POOL BARRIER PLAN

Project:	PROPOSED POOL, SPA & ALFRESCO
Client:	CANN
Site:	35 KEEL RETREAT, PORT GEOGRAPHE

Sheet title	**POOL BARRIER PLAN**
Date	21 Oct 2026
Revision	A
Scale	1:100

A3-03

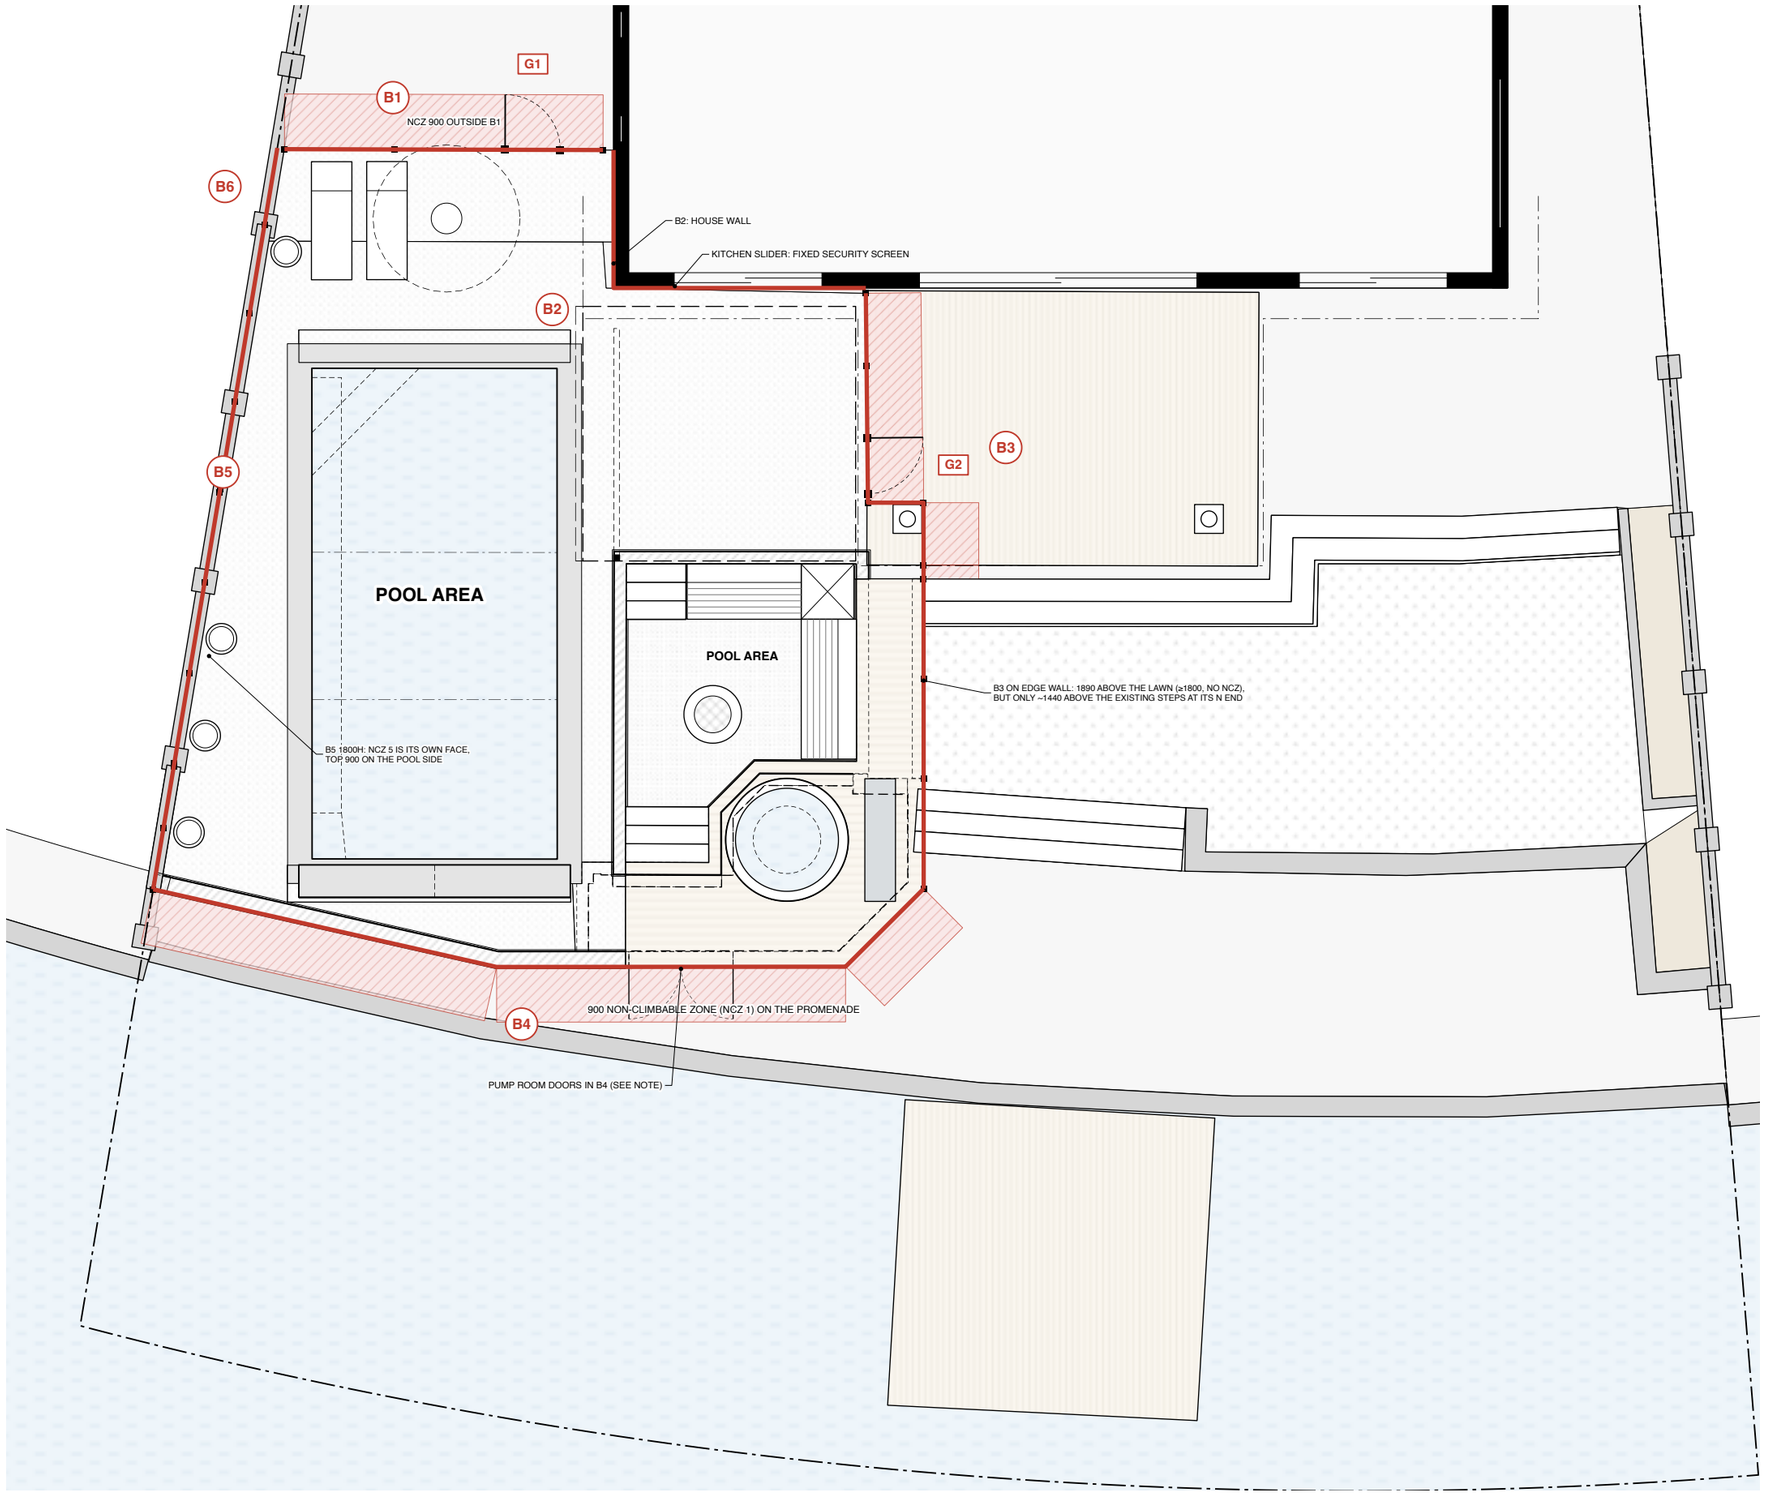
- B5 over the pots: 1800 above the paving, but the 550H pots stand about 170 off its pool side, so about 1250 above a pot. OK, or move them clear?
- B3 at its north end: only about 1440 above the existing lawn steps against it. OK as is?
- Pump room doors in B4, the canal-side barrier wall: their outside face must be non-climbable. Which door and finish?
- B1 and B3 stop 170 and 90 short of the house wall: close them up.
